**County of Loudoun**  
**Department of Planning**  
**MEMORANDUM**

**SUBJECT: SPEX 2006-0030, Lenah Auto Service**

**SUBJECT:** SPEX 2006-0030, Lenah Auto Service - 2<sup>nd</sup> referral

Attachment 1: Design Illustratives from SPEX 2003-0027, Piercy's Garage

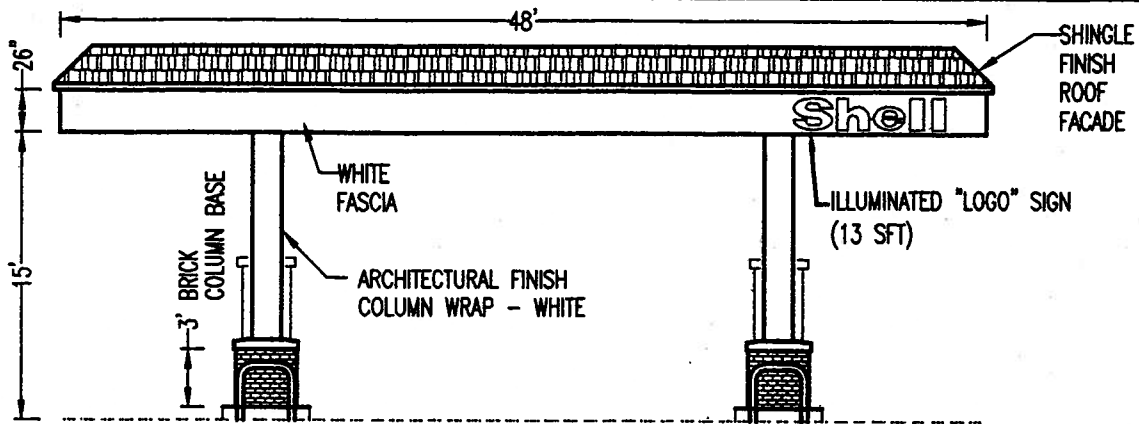
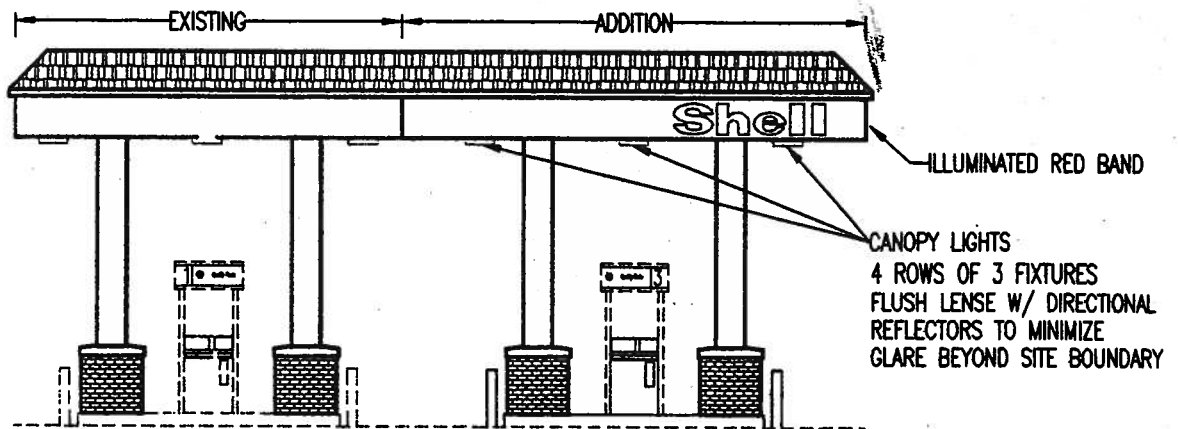
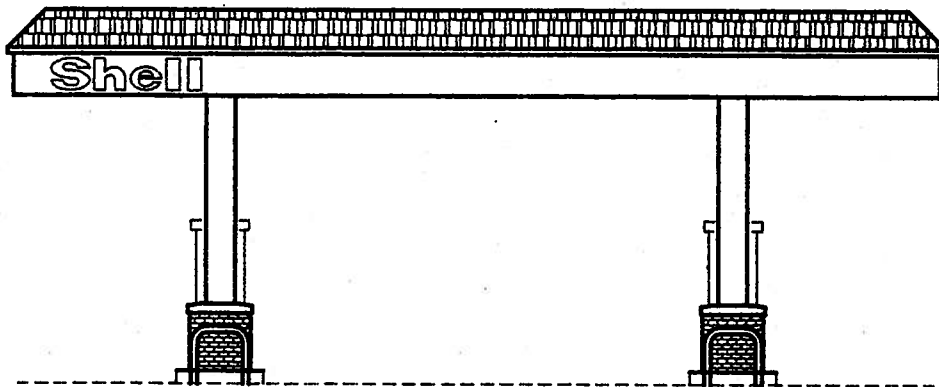
The proposal includes a canopy expansion that will house a total of four pumps. The proposed canopy will be 23' x 106', approximately twice the size of the existing canopy. The application does not include information on the design of the existing or proposed canopy, and whether or not the proposed canopy will be designed to complement the existing service station. The proposed canopy expansion should be reduced in size and designed in keeping with the character of the existing service station and surrounding community. Traditional architectural elements and details such as a low-pitched gable or hipped roof, a simple boxed cornice with molded soffit detail, and building materials such as asphalt shingle or standing seam metal roofing could be incorporated into the design of the canopy. A gas station approved on July 19, 2005 (SPEX 2003-0027, Piercy's Garage) incorporated architectural elements such as a shingle finish roof, and white column wraps. Attachment 1 is portion of the SPEX plat

approved for Peirce's garage, which serves as an example of what materials and design elements could be used in the design of the proposed canopy for this site.

***Staff recommends that the design and materials of the proposed canopy expansion complement the existing service station and surrounding area. Staff would be happy to work with the applicant to identify and discuss different design options for the proposed canopy.***

Attachment 1: Design Illustratives from SPEX 2003-0027, Piercy's Garage

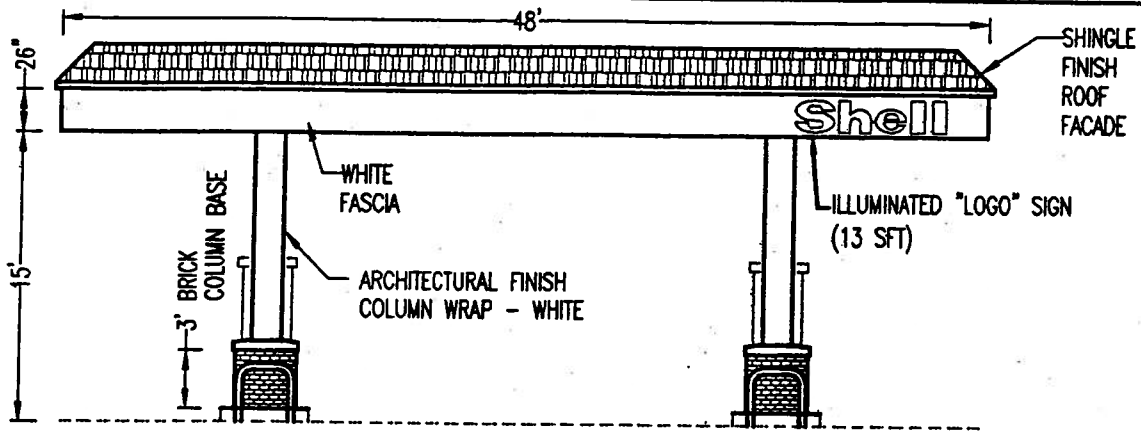
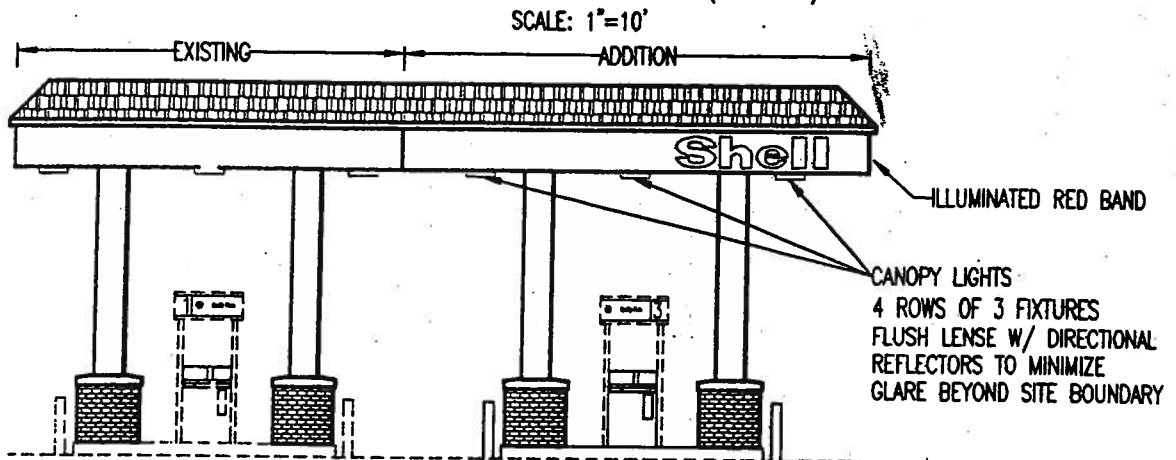
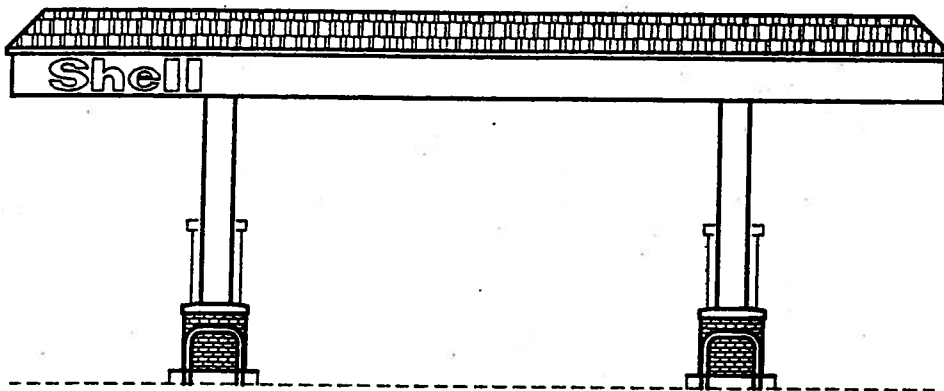
The applicant has responded by providing a canopy illustration on the SPEX plat, and indicating that the fascia will be white to match the main building color, and the logo text green to match the trim on building. Staff agrees with the color scheme, as the proposed colors will complement the color of the existing service station. However, staff continues to believe there is an opportunity to incorporate some other design features, such as a low hipped roof with shingle detailing, and white column wraps (see Attachment 1 - Design Illustratives from SPEX 2003-0027, Piercy's Garage).

***Staff recommends that the design and materials of the proposed canopy expansion complement the existing service station and surrounding area. Staff would be happy to work with the applicant to identify and discuss different design options for the proposed canopy, such as a low hipped roof with shingle detailing, and white column wraps, such as those seen on other canopies.***
